***Master Plan Amendment #2018-0005***  
***Text Amendment #2018-0006***  
***CDD Concept Plan Amendment #2018-0004***  
***Development Special Use Permit #2017-0019***  
***TMP Special Use Permit #2018-0065***  
***Special Use Permit #2018-0082***  
***Monday Properties – 2000 N. Beauregard Street***

<b>Purpose of Application</b>
The applicant requests approval of a Master Plan Amendment, Text Amendment, CDD Concept Plan Amendment, Development Special Use Permit with site plan and modifications, and associated Special Use Permits, including an additional penthouse, a coordinated sign program and a Tier 2 TMP, in order to construct a multi-family building with 292 units, sitewide landscaping and pedestrian improvements, new vehicular infrastructure and a 2,500 square foot amenity building.
<b>Special Use Permits and Modifications Requested:</b>
<ol style="list-style-type: none"> <li>1. Master Plan Amendment to Beauregard Small Area Plan Chapter to amend the use to include residential uses at the site and to increase the height and to amend the framework streets to remove the parallel road in the Adams Neighborhood;</li> <li>2. A text amendment to the Zoning Ordinance to amend the

Figure 10: Proposed Road Network for the Adams Neighborhood.

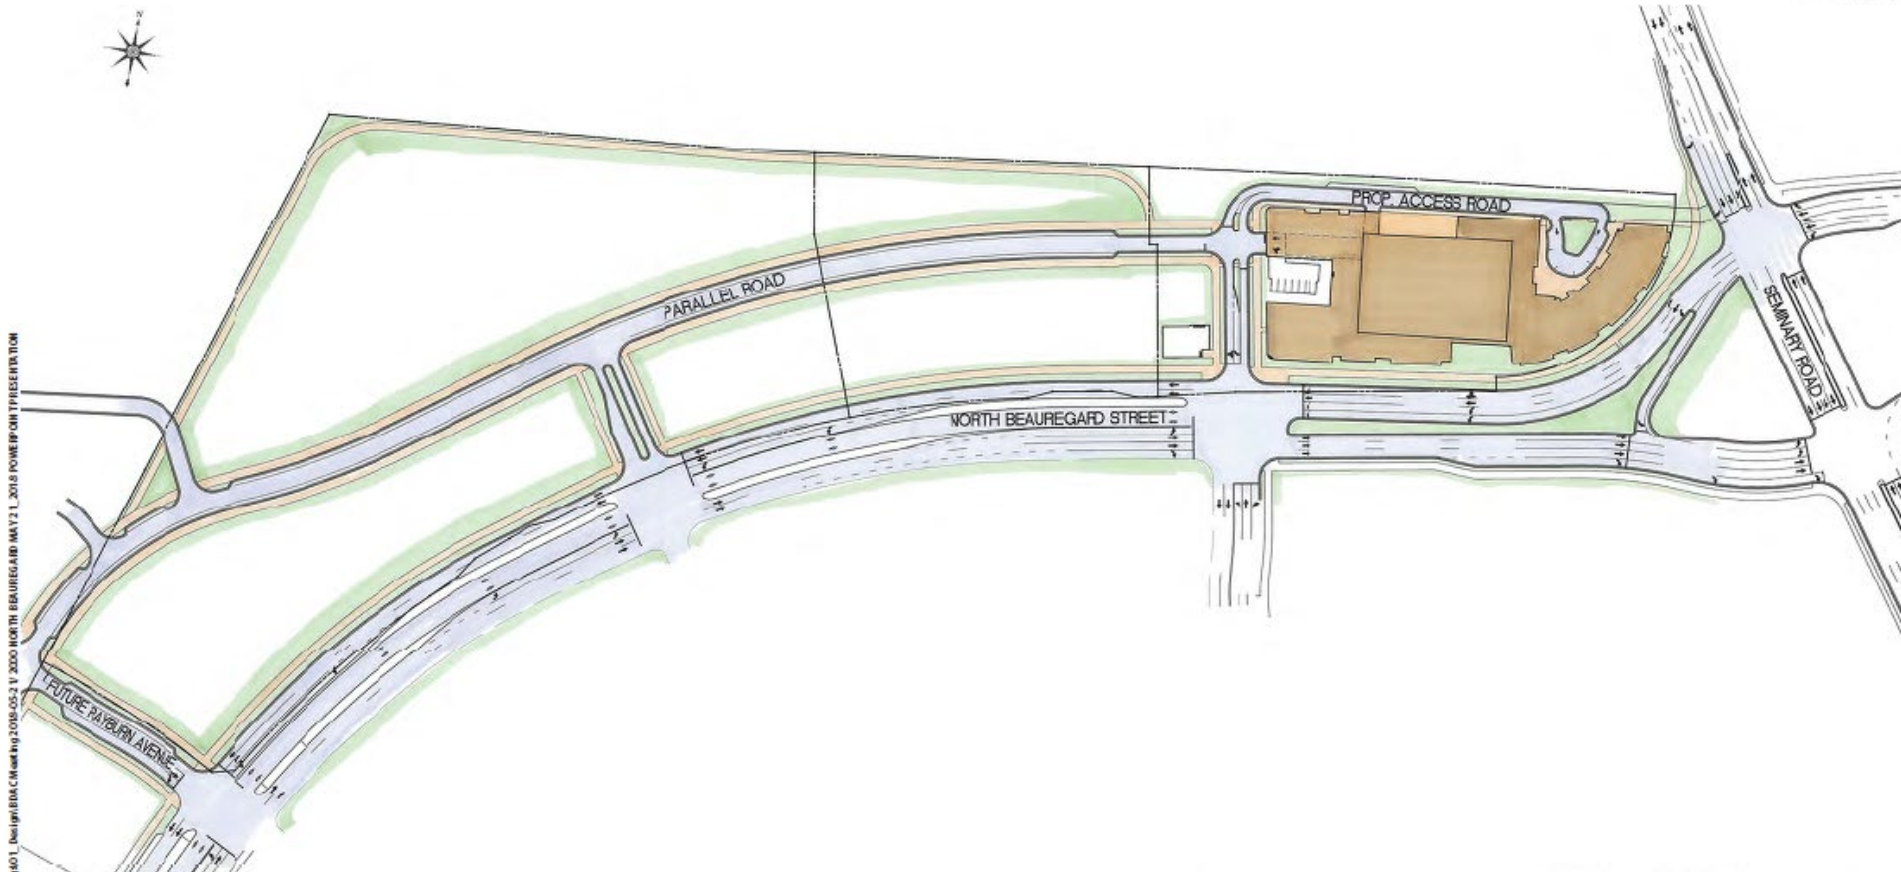
- *Changes in the Adams Neighborhood:*
  - The applicant team has agreed to remove the “Parallel Road” from the Adams Neighborhood which had been proposed to run along the northern border of the neighborhood and was located directly south of the Seminary Heights and Seminary Park communities. The previously planned for parallel road will instead be replaced with a 10’ wide multi-use trail for pedestrians and cyclists. A previously identified and more centrally located road through the Adams Neighborhood will be maintained to ensure vehicular connectivity and upgraded to provide the level of necessary vehicular service through the Adams Neighborhood at full-development levels. See Figure 10.

**Figure 15: Proposed Framework Streets**

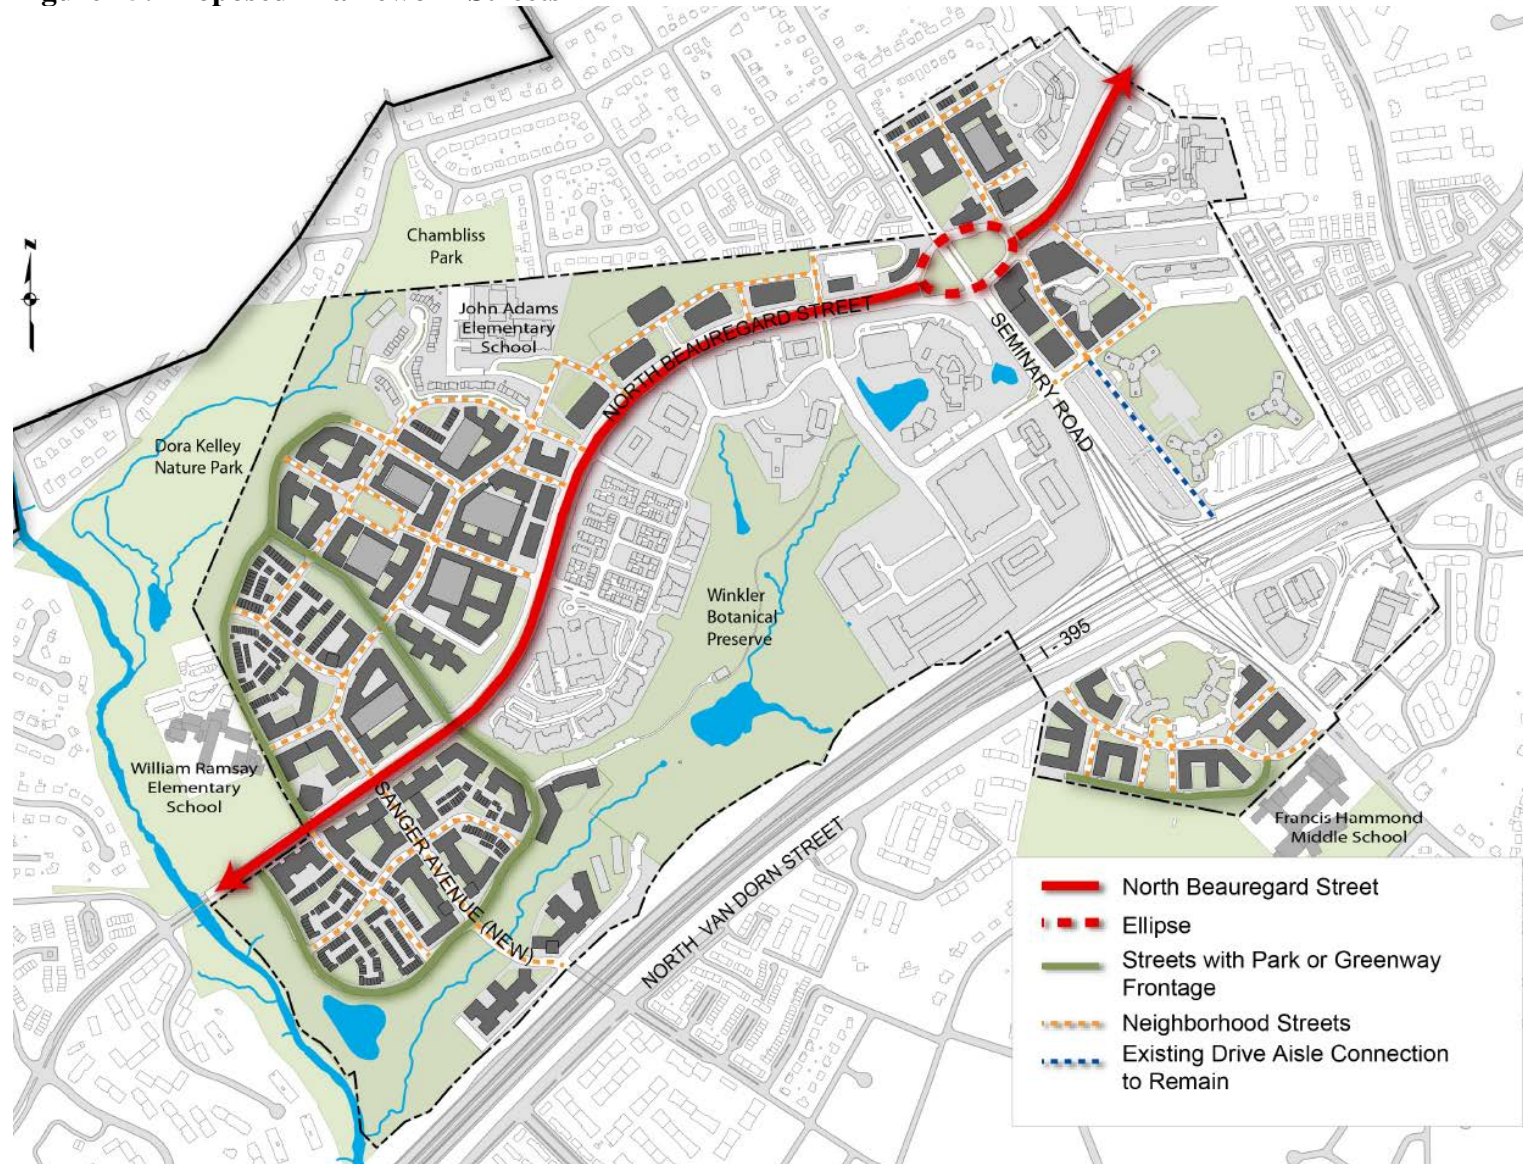
##### ***a. Amendment to Figure 15: Framework Streets***

CDD 21, Condition 100-a requires that the parallel road (labeled as a Neighborhood Street in Figure 15: Framework Streets) along the northern boundary of the Adams Neighborhood be reviewed as part of the first DSUP for the Adams Neighborhood. The recommendation of the

Beauregard Design Advisory Committee for this proposal, the first DSUP for the Adams Neighborhood, is that while the parallel road is needed, it should be placed more centrally within the neighborhood to provide a greater distance to adjacent residential neighborhoods to the north. The intent of the parallel road is to provide a network of circulation within the Adams Neighborhood. The proposed amendment provides a centrally located street connecting Mark Center Drive to the east and Rayburn Avenue to the west. This change allows for conversion of the previous parallel road to a 10' multi-use trail with a 15' buffer along the north boundary of the neighborhood for pedestrian and bicycle use. Staff supports the proposed amendment to Figure 15: Framework Streets, to reflect the centrally located parallel road and the removal of the northern parallel road as the configuration continues to enable circulation and urban scale blocks consistent with the intent of the Plan and is supported by adjacent residential communities.

**Amendment to Figure 15/Framework Streets Map to remove the neighborhood street along the northern boundary of the Adams Neighborhood.**

**Figure 25: Proposed Land Use**

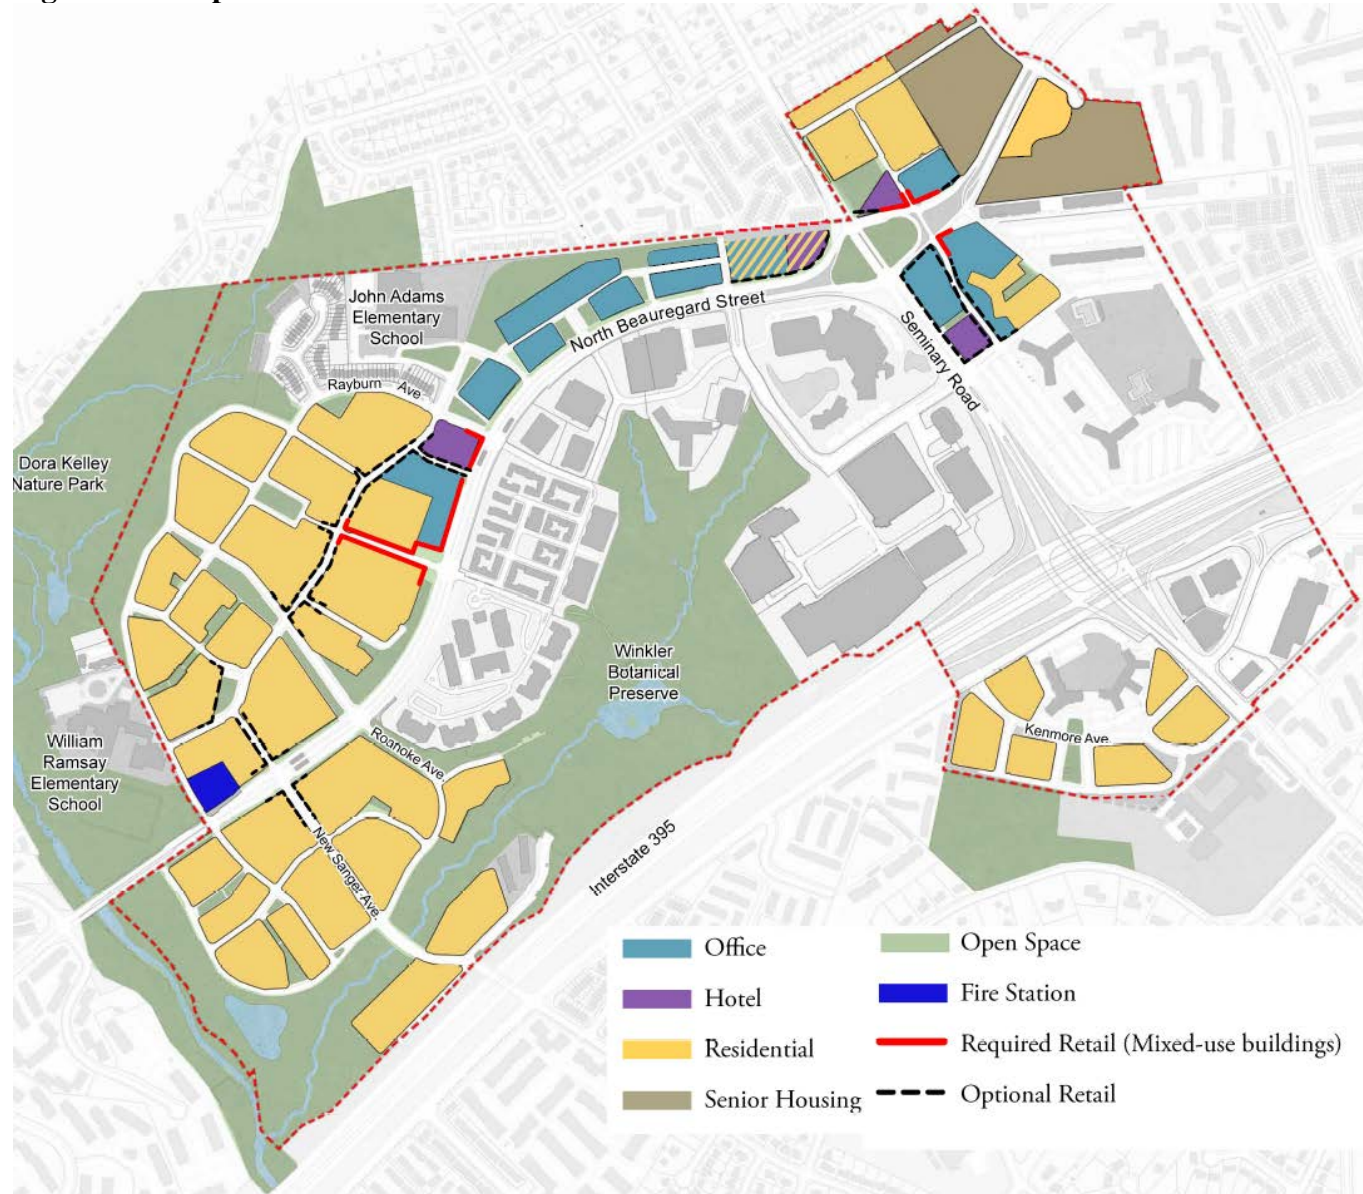
*b. Amendment to Figure 23: Land Use Strategy*

The applicant is proposing to construct a multi-family residential building while Figure 23: Land Use Strategy recommends hotel and office uses with optional retail along North Beauregard Street. The proposal for multi-family residential is a result of the significant market shifts in office locations since the approval of the Small Area Plan in 2012. Considering residential use in this location is also consistent with a recent analysis by the Urban Land Institute (see Attachment 7) that recommended the City permit flexibility for certain uses in the early phases of redevelopment to respond to market shifts and incentivize future redevelopment and Plan implementation. If residential use in the Adams Neighborhood is constructed, two thirds of the originally approved office and 100% of the originally approved hotel would remain. Staff recommends an amendment to Figure 23: Land Use Strategy to allow residential in addition to office, hotel and residential to add flexibility for residential use, while not precluding future office, hotel and retail at this location.

**Amendment to Figure 23/Proposed Land Use Strategy Map to change the land use designation on the map to add Residential.**

**Figure 30: Proposed Building Heights**

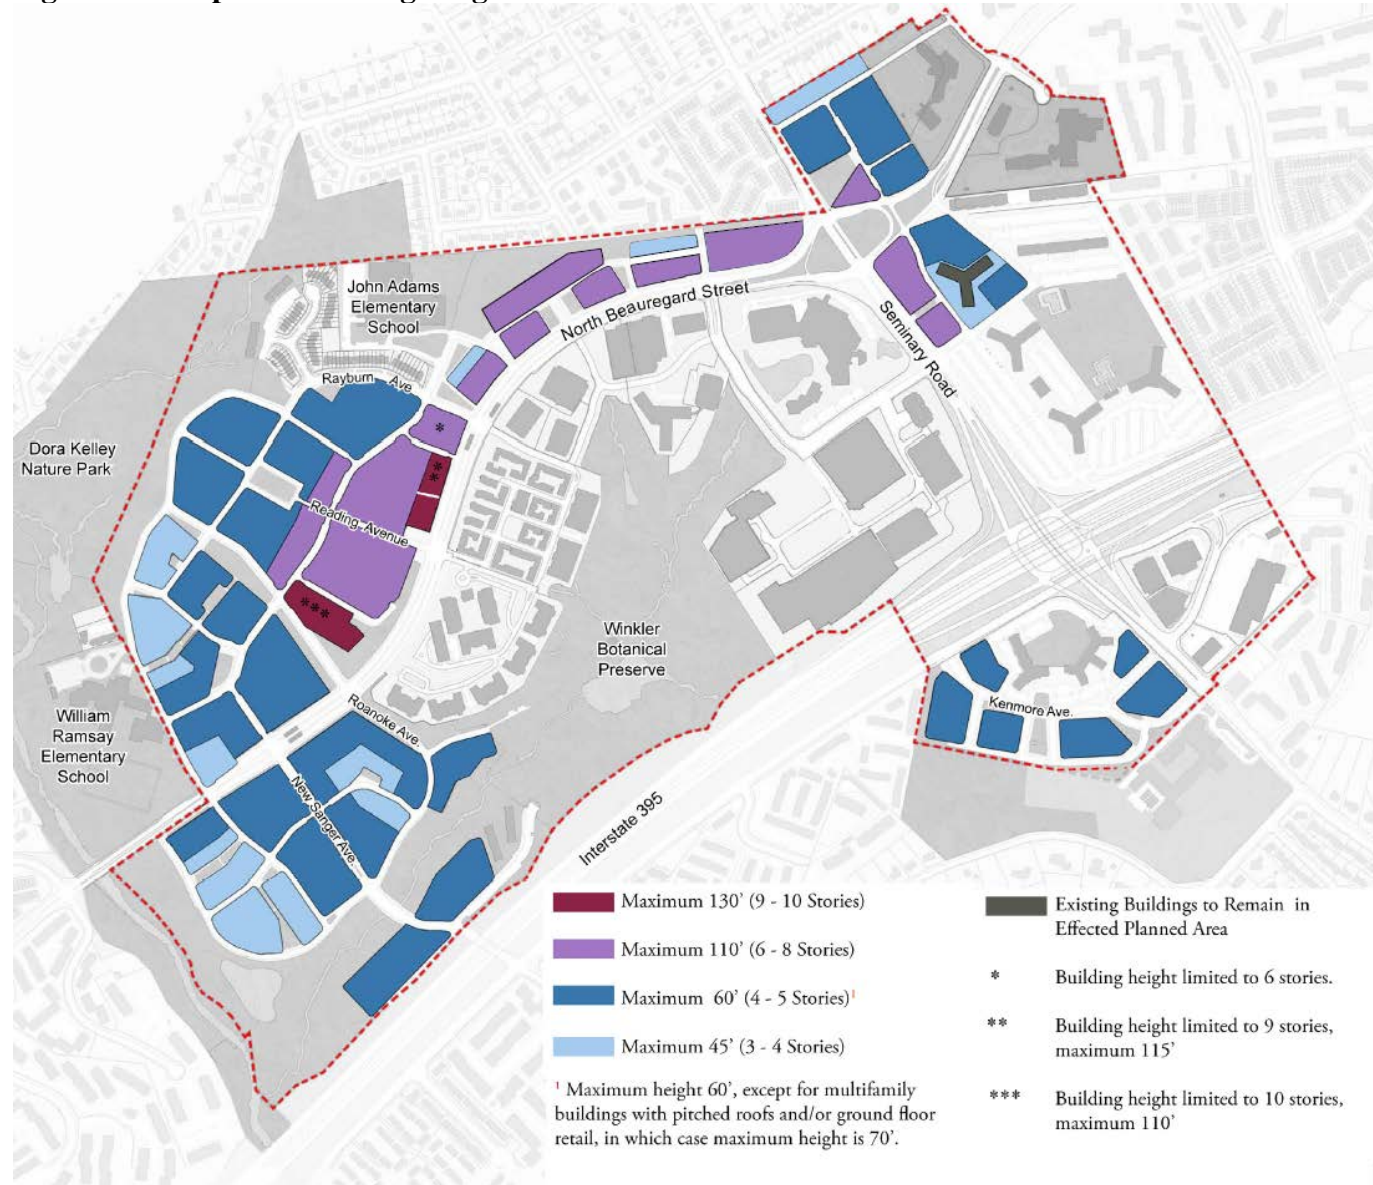
*c. Amendment to Figure 30: Building Heights*

Figure 30: Building Heights depicts heights on the western portion of the site to 45' (3-4 stories) and to 110' (six stories) on the eastern portion of the site. The proposed multi-family building is anticipated to exceed the recommended heights on the western portion of the site by 21' (two stories). The eastern portion of the site exceeds the six-story limit by one story but remains 15' below the maximum allowable building height.

The Plan intends for proposed development at N. Beauregard Street and Seminary Road to be urban in form and scale much like that of comparable developments along comparable size roads, while also providing adequate transition to the existing lower scale residential to the north. To fulfill this intent, a majority of the seven-story portion of the building is located along the intersection of N. Beauregard Street and Seminary Road as it hugs the curve of the road away from the adjacent residential to the north. The remainder of the building, closest to the adjacent northern neighborhood, steps down to six-stories. The applicant has provided a 45' setback along the northern boundary of the site as per CDD 21 condition 100-g, while also providing between 15' and 17' of landscaped and fenced screening along the northern property line. The applicant has also worked with Staff to provide building articulation, a courtyard and a mix of building materials

along the north façade of the building, including screening of the above grade garage, as recommended in the Plan and Design Standards. For these reasons, Staff recommends amending Figure 30: Building Height to allow the Maximum 110' (6-8 stories) zone for the entire parcel.

**Amendment to Figure 30/Proposed Building Heights Map to allow a maximum height of 110' (6-8 stories).**
